**CITY OF BERKELEY**  
**SANITARY SEWER REHABILITATION PROJECT**  
**PARNASSUS ROAD, ET AL.**

SPECIFICATION NO. 23-11548-C  
**ADDENDUM NO. 2**

The City of Berkeley has revisions, and/or additions on the following Plan Sheets in the Contract Plans for Specification No. 23-11548-C, Sanitary Sewer Rehabilitation Project – Parnassus Road, et al.:

SANITARY SEWER REHABILITATION  
LATHAM LN  
PLAN AND PROFILE

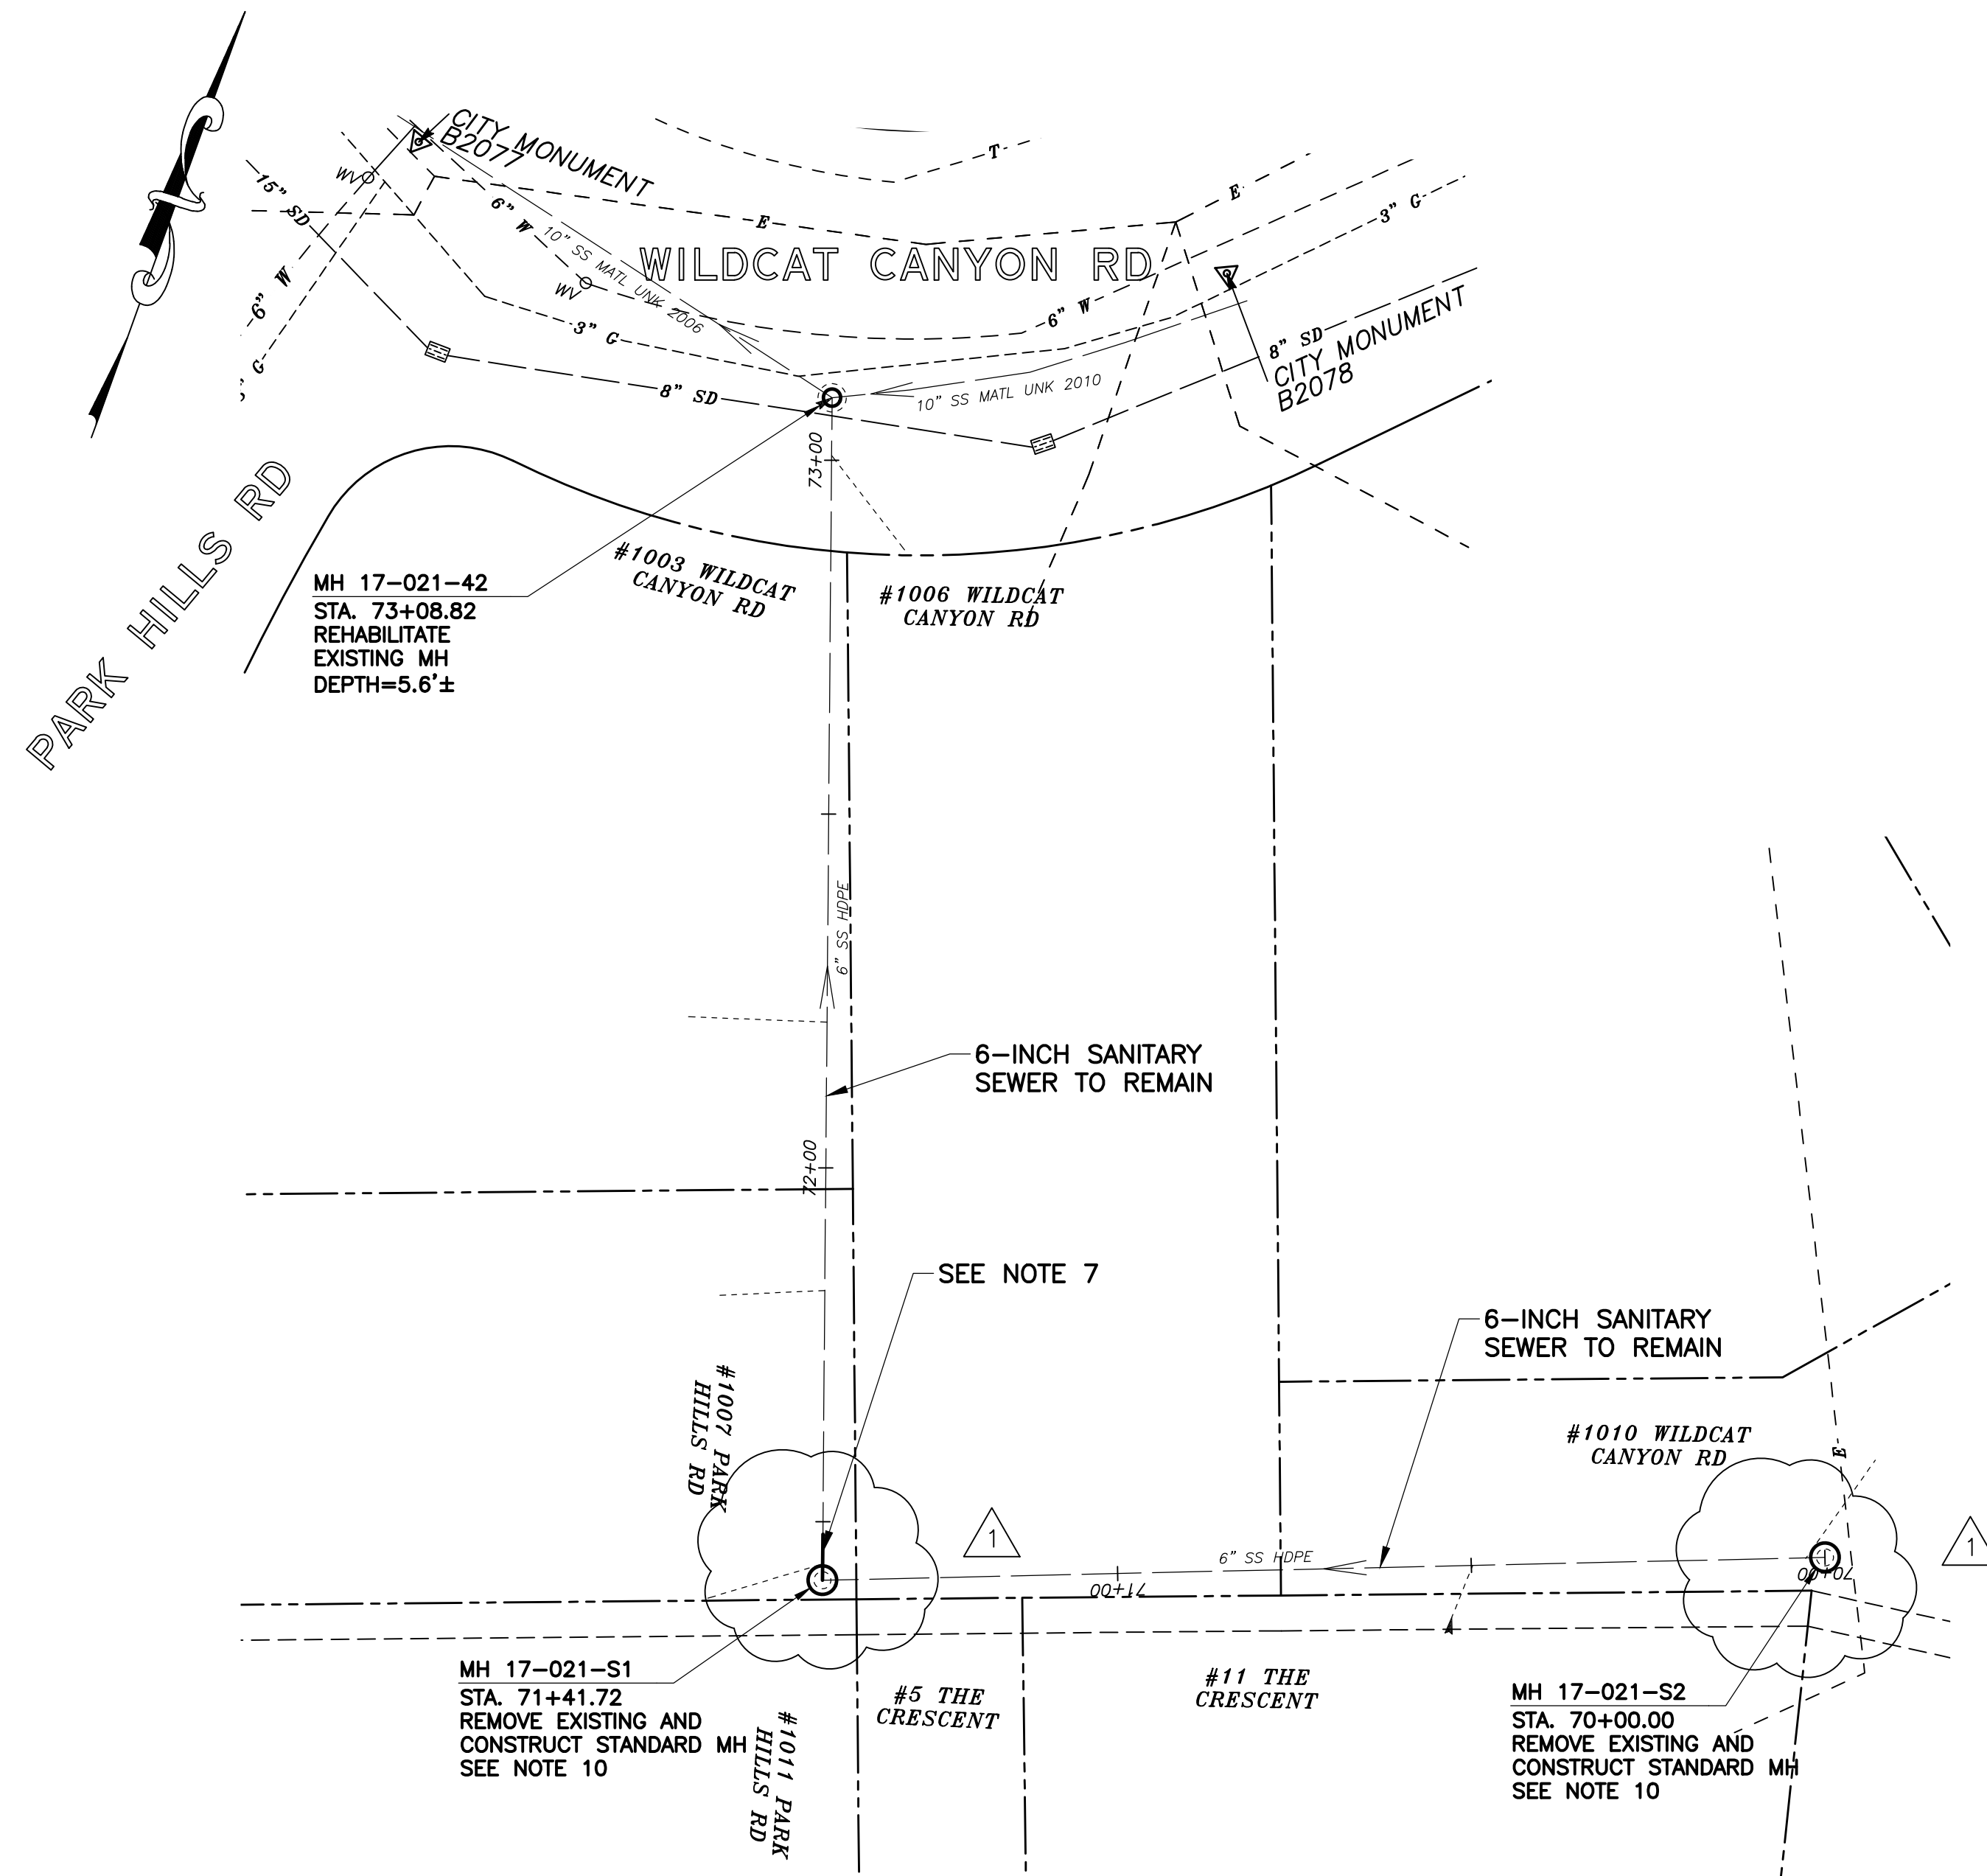
Plan Sheet Title	Plan Sheet Number	Notes
1005 CRESTON RD	Sheet 10 of 58	Revision 1
LATHAM LN	Sheet 11 of 58	Revision 1
1010 WILDCAT CANYON RD	Sheet 14 of 58	Revision 1
1101 MILLER AVE	Sheet 16 of 58	Revision 1
40 STEVENSON AVE	Sheet 19 of 58	Revision 1
1169 MILLER AVE	Sheet 20 of 58	Revision 1
AJAX PL	Sheet 27 of 58	Revision 1
1462 CAMPUS DR	Sheet 36 of 58	Revision 1
10 SUMMIT LN	Sheet 39 of 58	Revision 1
1530 SUMMIT RD	Sheet 45 of 58	Revision 1
CAMPUS DR – 1	Sheet 50 of 58	Revision 1
3082 BUENA VISTA WAY	Sheet 52 of 58	Revision 1
96 TAMALPAIS RD	Sheet 54 of 58	Revision 1
LA LOMA AVE 2	Sheet 57 of 58	Revision 1

**Revise** Special Condition No. 41 to add Sheet 11 – Latham Ln and Creston Rd from MH 17-713-B2 to MH 17-713-17 and remove Campus Dr at MH 17-702-A4 and MH 17-605-87.

- Sheet 11** - **Latham Ln and Creston Rd from MH 17-713-B2 to MH 17-713-17**
- Sheet 12** - Overlook Rd and The Crossways from MH 17-021-C4 to 17-021-B9

SANITARY SEWER REHABILITATION  
1010 WILDCAT CANYON RD  
PLAN AND PROFILE

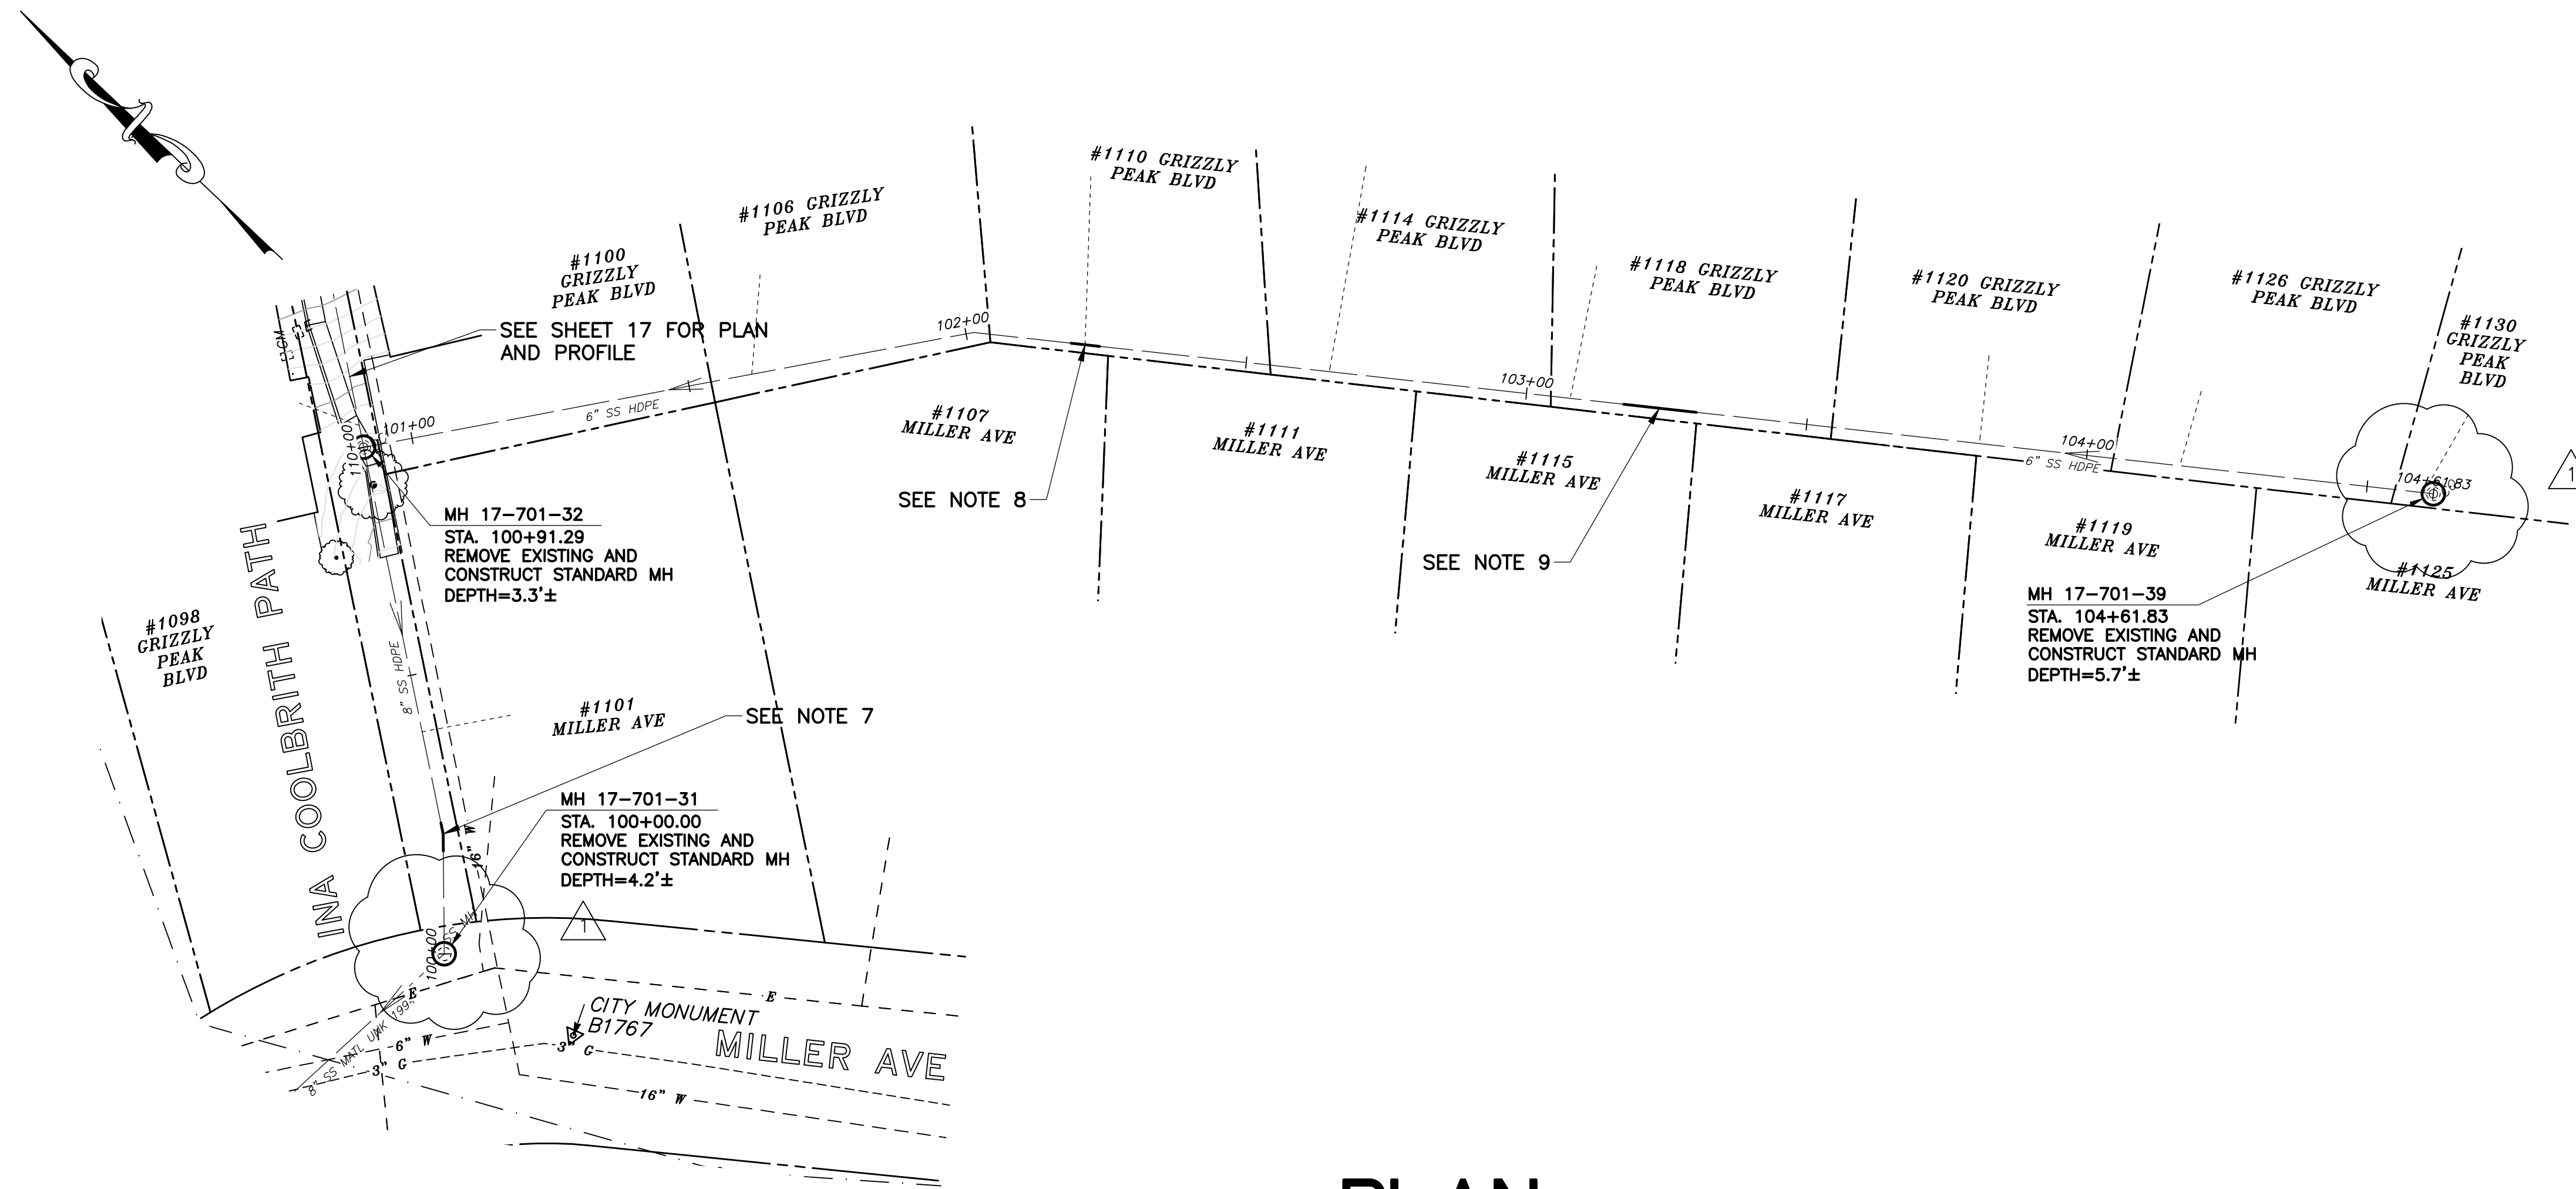
- WORK SHOWN ON THIS SHEET IS LOCATED IN CITY OF BERKELEY FIRE ZONE 2 AND IS SUBJECT TO ALL WORK REQUIREMENTS AND RESTRICTIONS.
- REPAIR JOINT SEPARATION 5± LF STA 71+43± TO 71+47± (METHOD "C").

- Sheet 13** - Overlook Rd from MH 17-021-D4 to MH 17-021-D7
- Sheet 14** - Wildcat Canyon Rd from MH 17-021-S2 to MH 17-021-42
- Sheet 16** - Miller Ave from 17-701-39 to 17-701-31

SANITARY SEWER REHABILITATION  
1101 MILLER AVE  
PLAN AND PROFILE

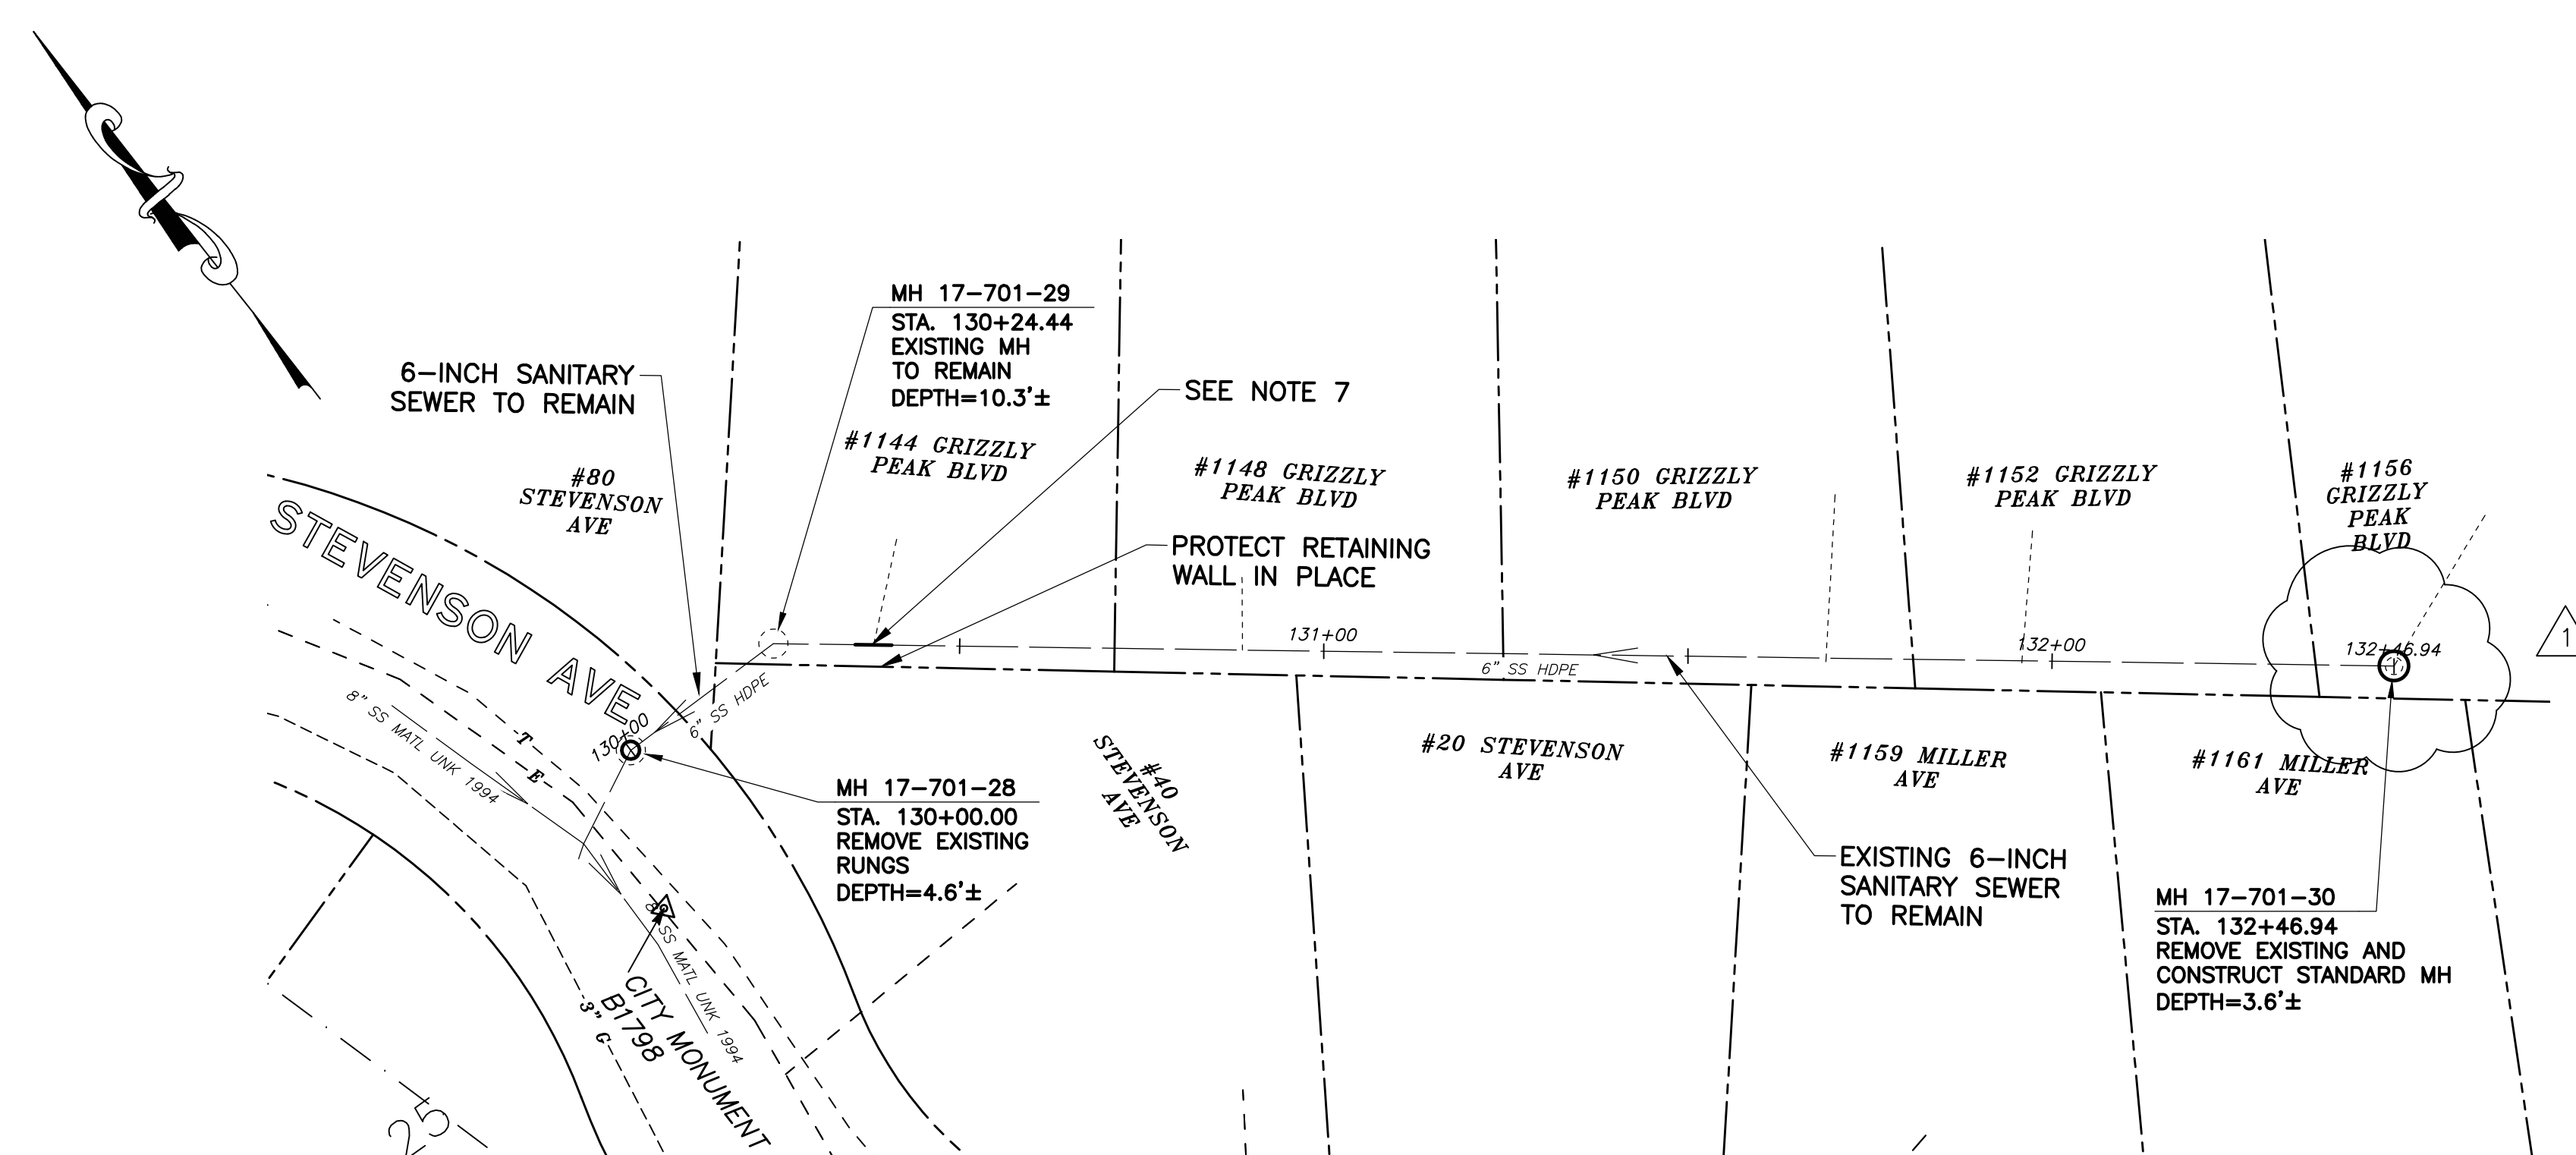
6. WORK SHOWN ON THIS SHEET IS LOCATED IN CITY OF BERKELEY FIRE ZONE 2 AND IS SUBJECT TO ALL WORK REQUIREMENTS AND RESTRICTIONS.
7. REPAIR SEPARATED JOINTS STA 100+18 TO 100+23± (METHOD "C").

8. REPAIR DEFECTIVE TAP STA 102+21± (METHOD "C").
9. REPAIR SEPARATED JOINTS STA 103+17± (METHOD "C").
10. ONLY HAND EXCAVATION (METHOD "C") WILL BE ALLOWED FOR WORK LOCATED ON PRIVATE PROPERTY.
